# **VALIDATION REPORT**

**Nam Pong Hydropower Project**

**REPORT NO.: 11011116**

**China Environmental United Certification Center Co., Ltd (CEC)**

The following figure shows the plant operation flow diagram of the proposed project, but PP confirm the lay-out of power transmission line from generation to gird is not final version.

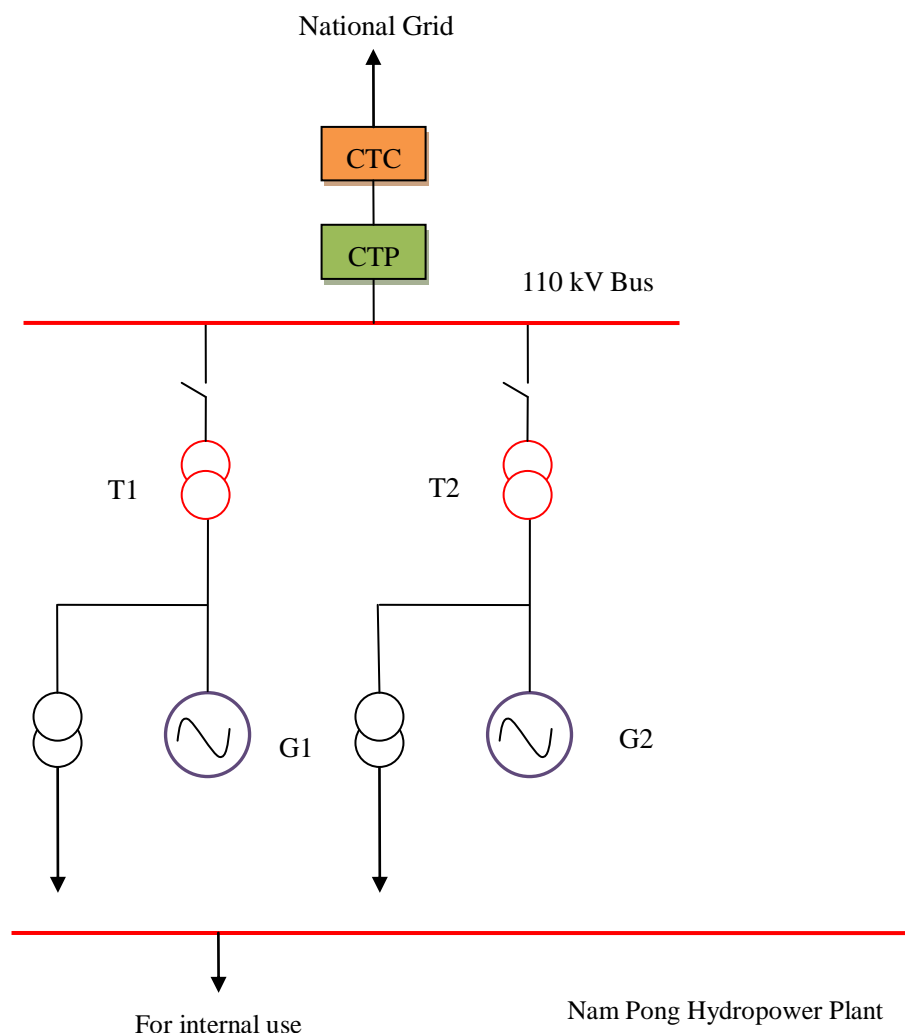
CAR04 was raised to ask PP to supplement the Layout of Power Transmission Lines from the Generation to the Grid with the Metering System. The Layout of Power Transmission Lines from the Project to the Grid with the Metering System has been applied in the revised PDD. This CAR was closed. For detailed resolution please see Table 2 in Appendix A.
